**ORINATION FORM**

**Proposed Revisions to a Standard Plans Index**

Index Number: 521-600

Index Title: MSE Wall Coping (Precast or C-I-P)

SECTION B-B  
PRECAST COPING

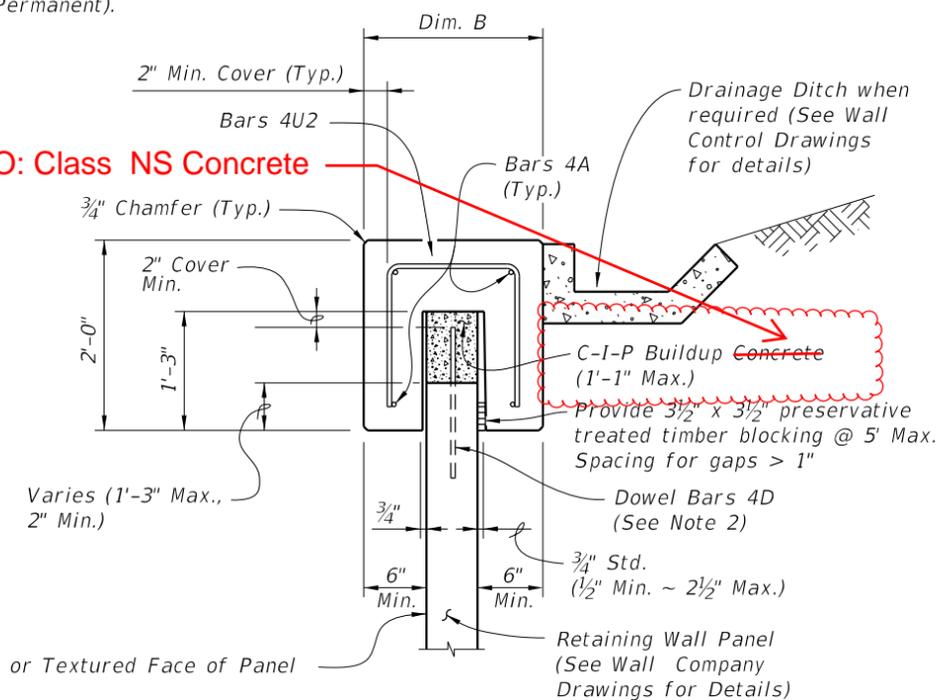
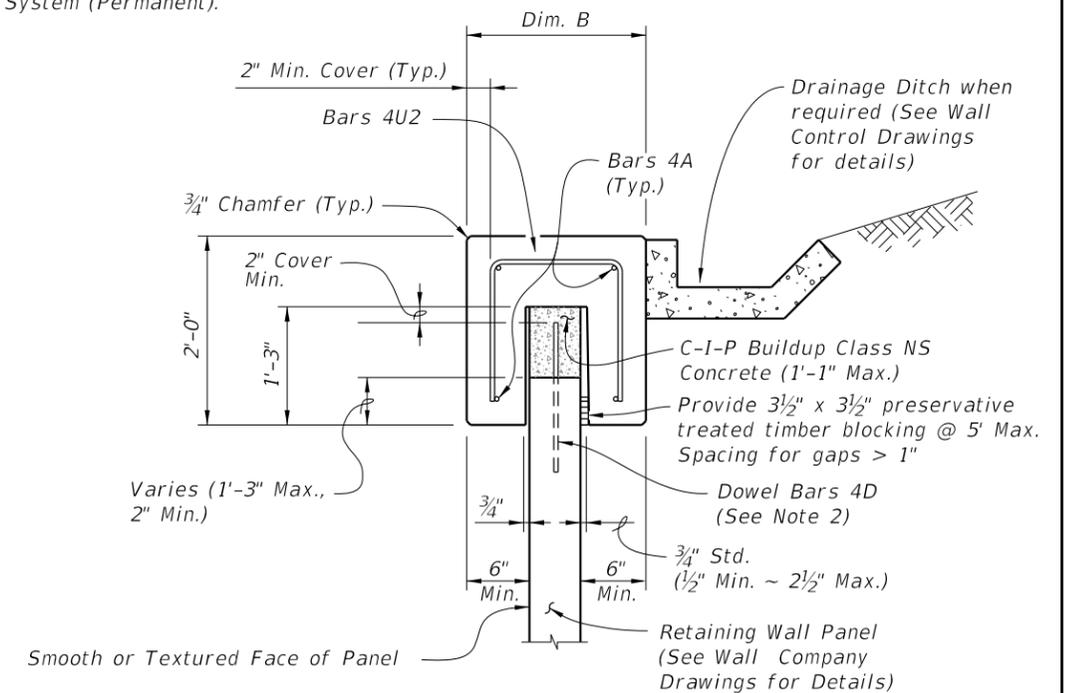
Changed C-I-P Buildup Concrete (1'-1" Max.) callout in the PRECAST COPING SECTION B-B to C-I-P Class NS Concrete (1'-1" Max.).

CIP buildup concrete type was never clarified. SDO review deems Class NS is acceptable because the concrete buildup section is not meant to transfer any meaningful load to the wall other than self weight.

**CHANGED TO: Class NS Concrete**
